SUNDRY NOTICES AND REPORTS ON WELLS

8. Well Name and No. El Zorro E Federal 2

9. API Well No. 3004120427

Action 533843

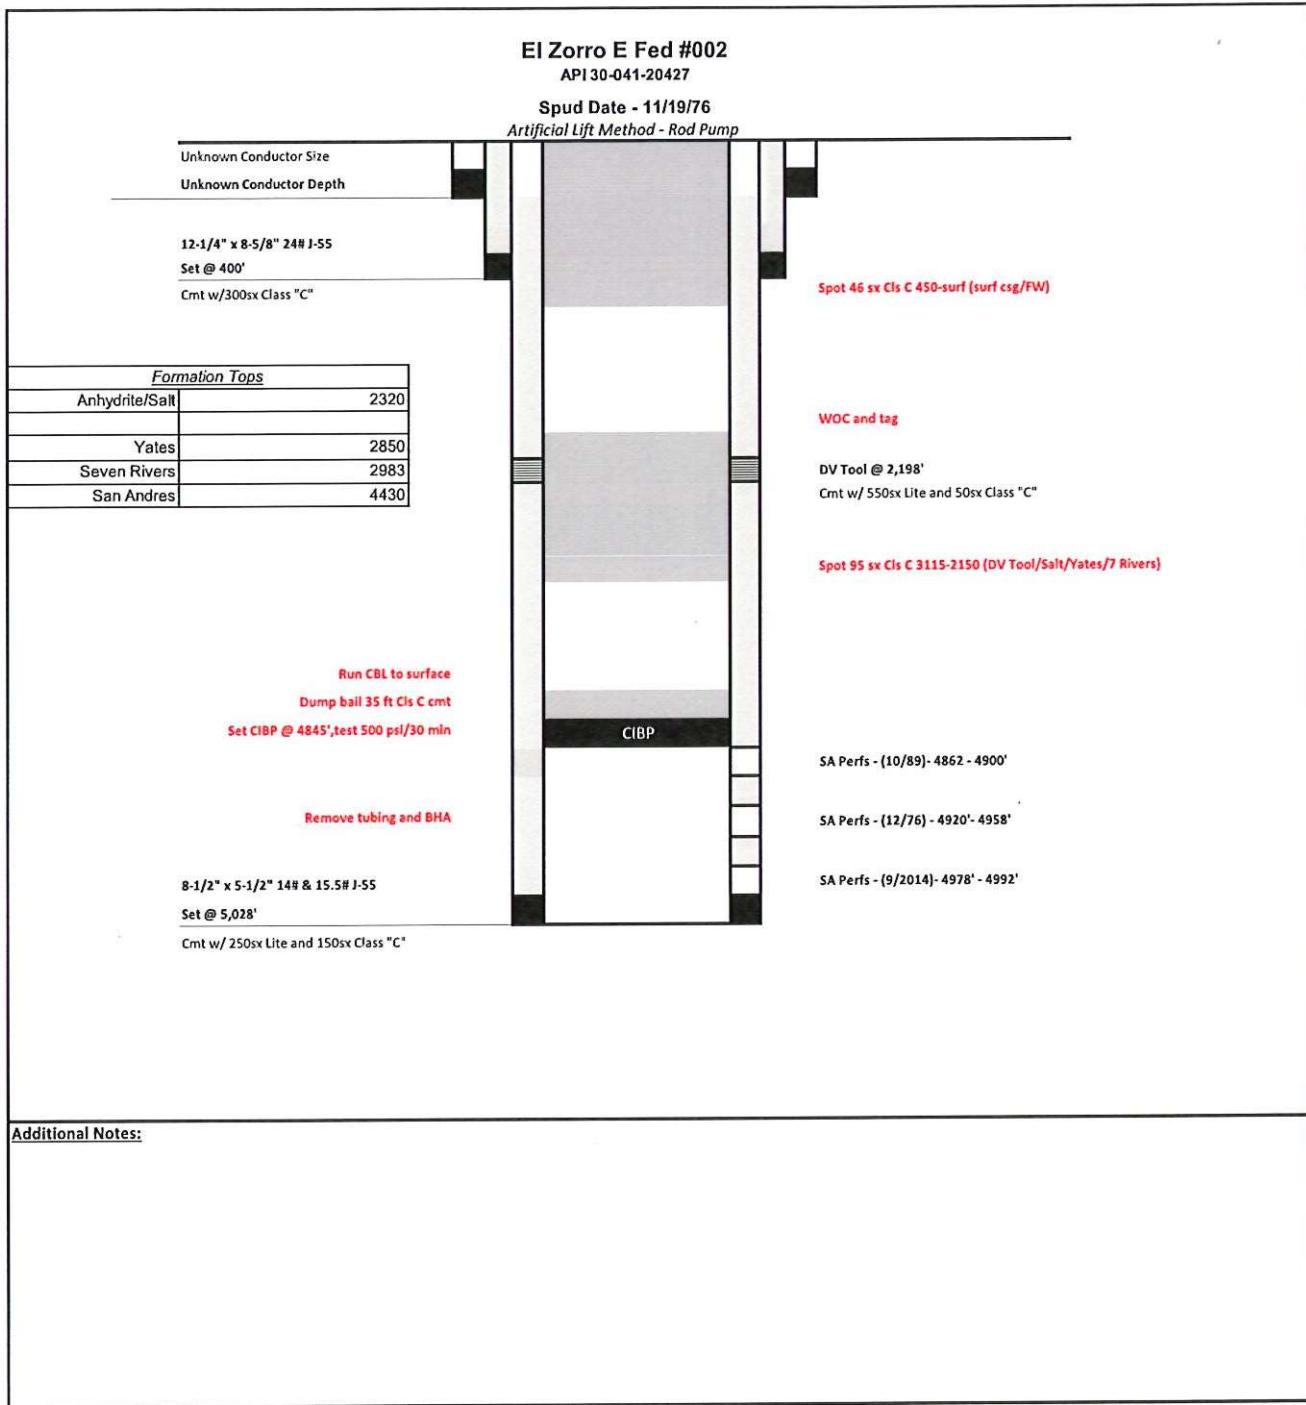
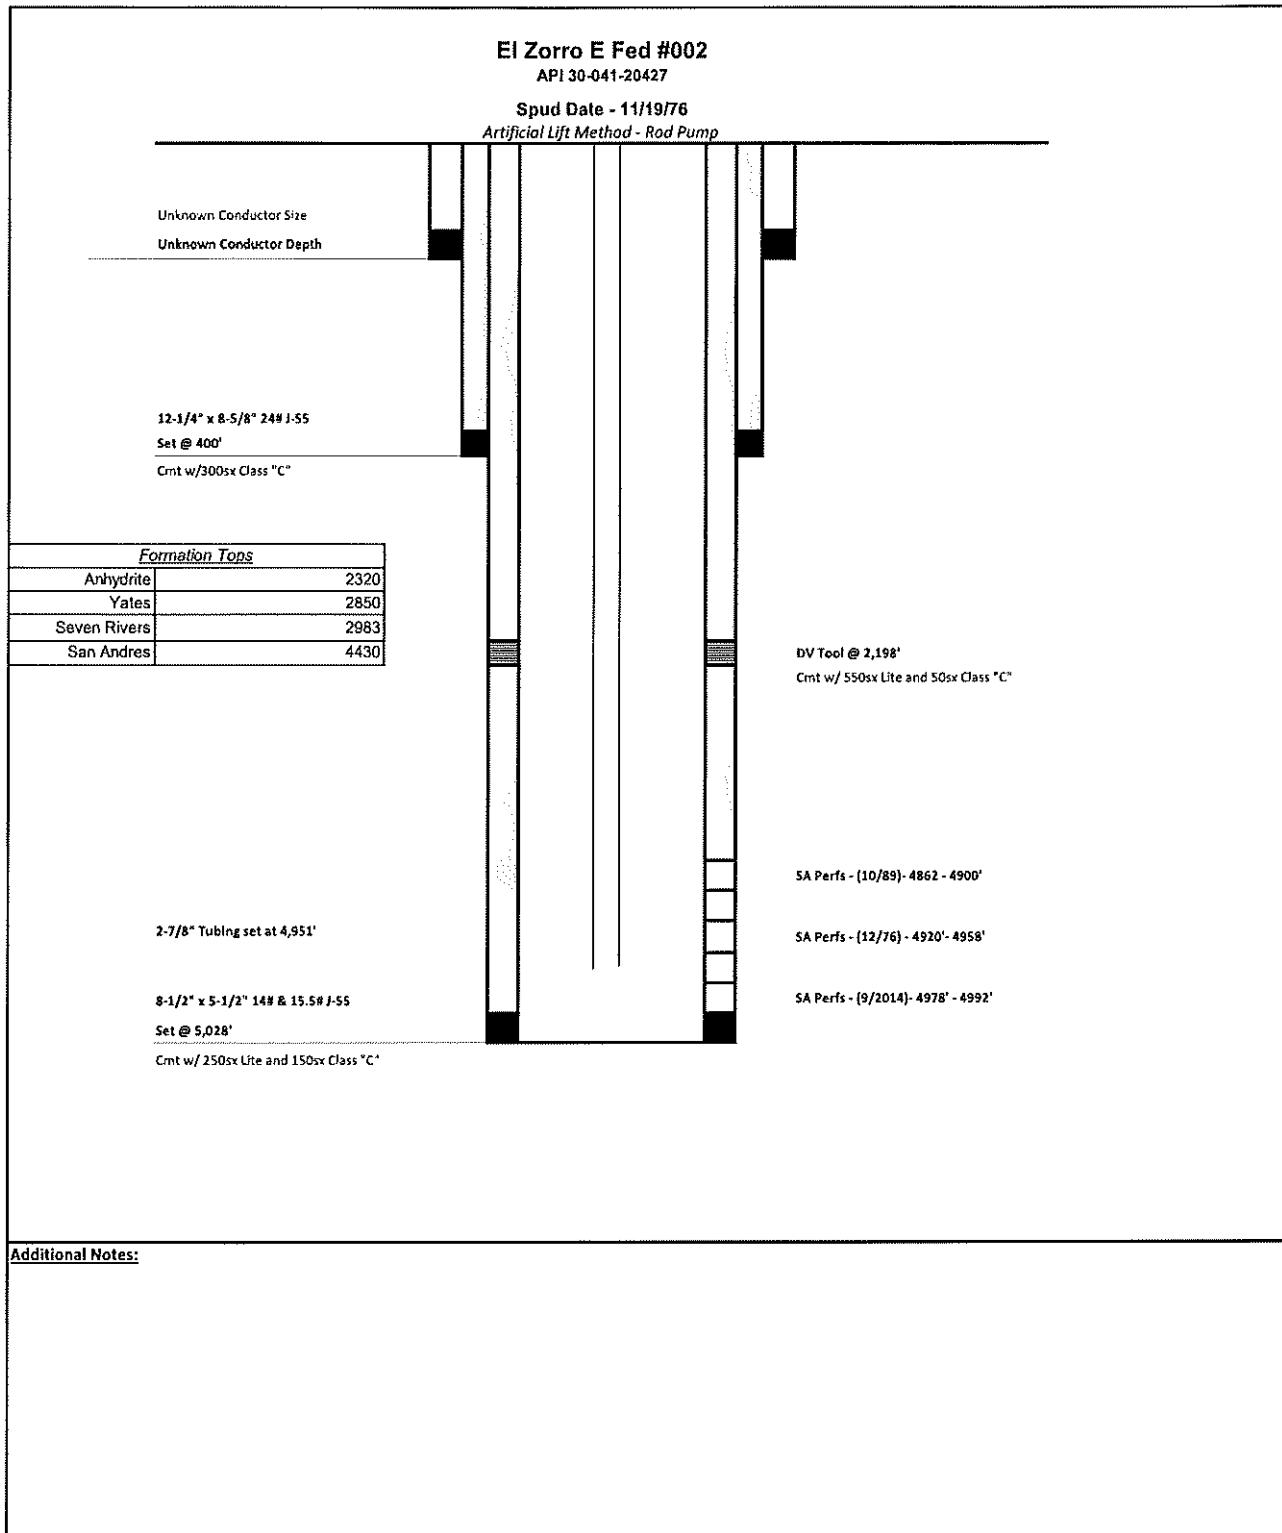
Attached Proposed plugging steps (depths, cement sacks, etc) are in red on the planned WBD.

- 1. Operator shall place CIBP at 4,845' and place a minimum of 25 sx of Class C cement on top. WOC and TAG.**
- 2. Operator shall place a balanced Class C plug from 3,115'-**2,148'** to seal the Yates, Salt and DV tool. WOC and TAG. Tag must be a minimum of 2,148' (50' above the DV tool).**
- 3. Operator shall perf at 450' and squeeze cement class C cement to surface' to seal the 8-5/8" casing shoe.**
- 4. Dry hole marker must be below ground.**
- 5. Surface reclamation will need to be completed once the well bore has been plugged. Please contact rflores@blm.gov for additional information.**
- 6. See Attached for general plugging stipulations.**

| Created By | Condition | Condition Date |
|------------|---|----------------|
| gcordero | Run CBL from 4845' to Surface | 12/23/2025 |
| gcordero | Spot 25 sacks cement 4500' - 4300' - Top of SA | 12/23/2025 |
| gcordero | Add Cement to plug at 3115' - Start at 3135' - 50' below the 7Rivers | 12/23/2025 |
